SUNDRY NOTICES AND REPORTS ON WELLS

| Do not use this form for proposals to drill or to re-enter an abandoned well. Use form 3160-3 (APD) for such proposals. | | | 6. If Indian, Allottee | 6. If Indian, Allottee or Tribe Name | |
|---|---|--|--|--|--|
| 1. Type of Well ☑ Oil Well ☐ Gas Well ☐ Other | | | | 8. Well Name and No. FORTY NINER RIDGE UNIT 105H | |

SURVEY OF THE PROPOSED FORTY NINER RIDGE 22 BATTERY

49er Production facility

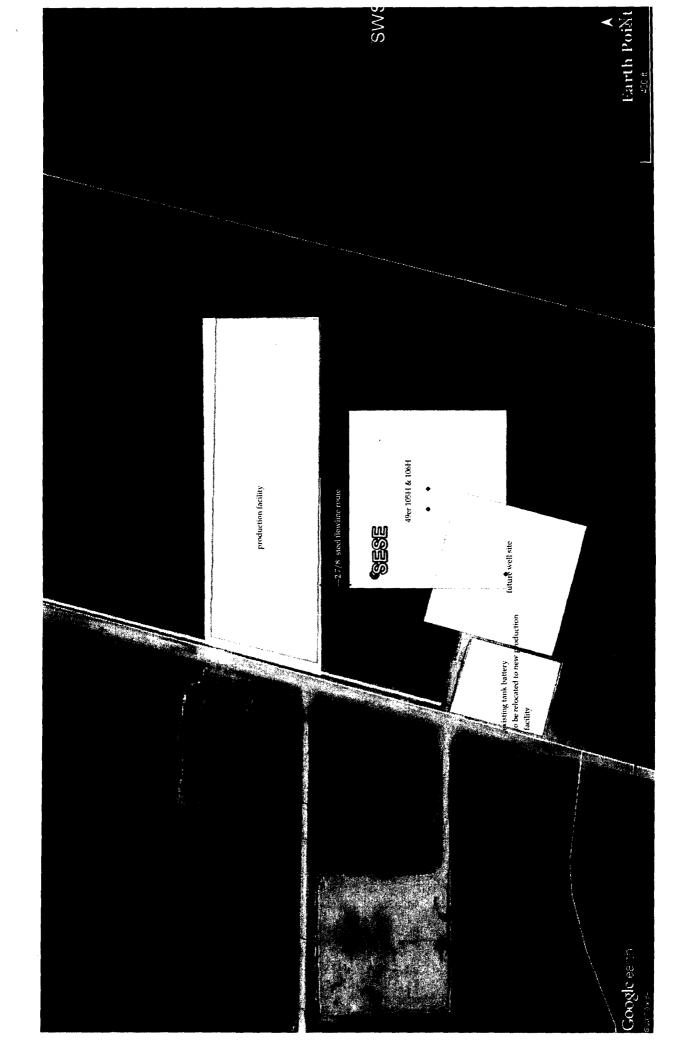
I need for this sundry (in writing) the size of the pad, length, type and size of flow lines, Buried or surface and a plate.

Paul – the pad size for this will be 910' x 310', the flowline will be above ground from the well head to the battery site, approximately 81' (map attached). The existing tank battery will be moved to the new production facility when it is approved. Please let me know if you need anything else. Thanks,

MEWBOURNE OIL COMPANY SURVEY OF THE PROPOSED FORTY NINER RIDGE 22 BATTERY SECTION 22, T23S, R30E,

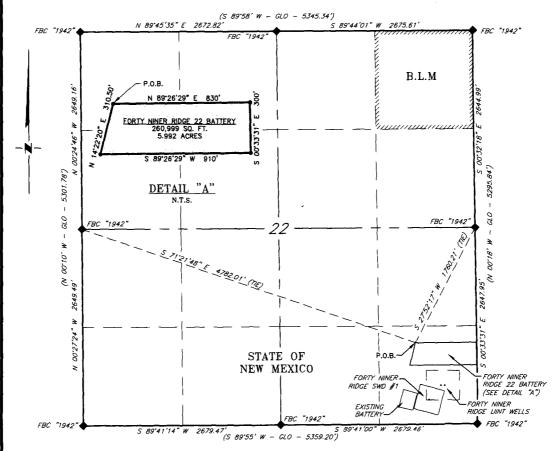
Actual plate of the pad and size of it, the location and length of the flowlines, location and length of access road.

In Writing the length, size, and psi of the flowlines, where are they coming and going to. Length and width of the road to the facility

Actual plate of the pad and size of it. – Plat is attached. Size is 910' x 310'.

the location and length of the flowlines – map attached. Flowline will be from the NW corner of well pad (105H & 106H) to the SW ¼ of the production facility. Flowline will be 81' in length.

location and length of access road - there is no new access road. The battery pad is directly next to the existing lease road.

In Writing the length, size, and psi of the flowlines. Length 81 feet, 2 7/8" steel, 120 psi.

where are they coming and going to. Coming from Forty Niner Ridge Unit #0105H & #106H well pad, NW corner to proposed battery site about 225' east of the SW corner.

Length and width of the road to the facility - no new road is required.
